SUBJECT: ISSUANCE OF AMENDMENT NO. 18 TO FACILITY OPERATING LICENSE
R-75 - OHIO STATE UNIVERSITY RESEARCH REACTOR (OSURR)
(TAC NO. MC5198)

AMENDMENT TO FACILITY OPERATING LICENSE

Amendment No. 18
License No. R-75

SAFETY EVALUATION BY THE OFFICE OF NUCLEAR REACTOR REGULATION

Figure 6.1: Administrative Organization

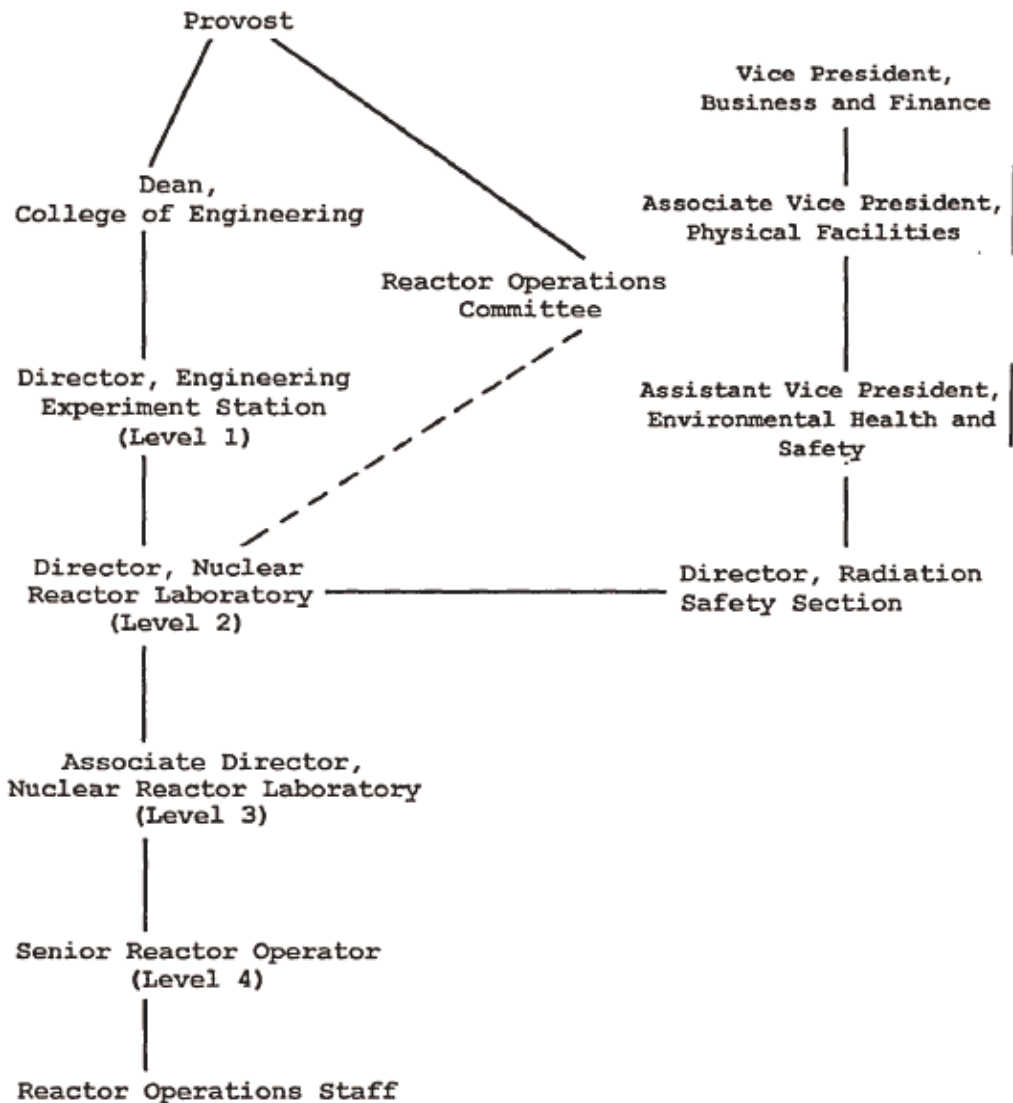
The amendment adds two existing positions between the Vice President of Business and Finance and the Director of Radiation Safety Section to the Administrative Organization, Figure 6.1 of the Technical Specifications (TS). Those positions are the Assistant Vice President of Physical Facilities and the Associate Vice President of Environmental Health and Safety.

The proposed change to Figure 6.1 of the OSURR TSs adds two positions between the Vice President of Business and Finance and the Director of Radiation Safety Section to the Administrative Organization. Those positions are the Assistant Vice President of Physical Facilities and the Associate Vice President of Environmental Health and Safety. The licensee states that the addition of these two positions does not lessen the independence of the Radiation Safety Section from the OSU Nuclear Reactor Laboratory, of which the OSURR is a part. They indicate that the Director, Nuclear Radiation Laboratory, reports to the Provost, also the Executive Vice President, and the Director, Radiation Safety Section, reports to the Senior Vice President for Business and Finance. The licensee explains that the Provost and the Senior Vice President are independent and report directly to the University President, which is no less independent than the structure prior to the change.

the individual or group responsible for implementing the radiation protection program shall report to level 1 or level 2 of the OSURR Management. In the case of the OSU, both before and after the TS change, the Director, Radiation Safety Section report to above level 1. The NRC staff finds that the independence of the Radiation Safety Section from the OSU Nuclear Reactor Laboratory is not lessened by this change. The health and safety of the public is not diminished by this change thus the staff finds it acceptable.
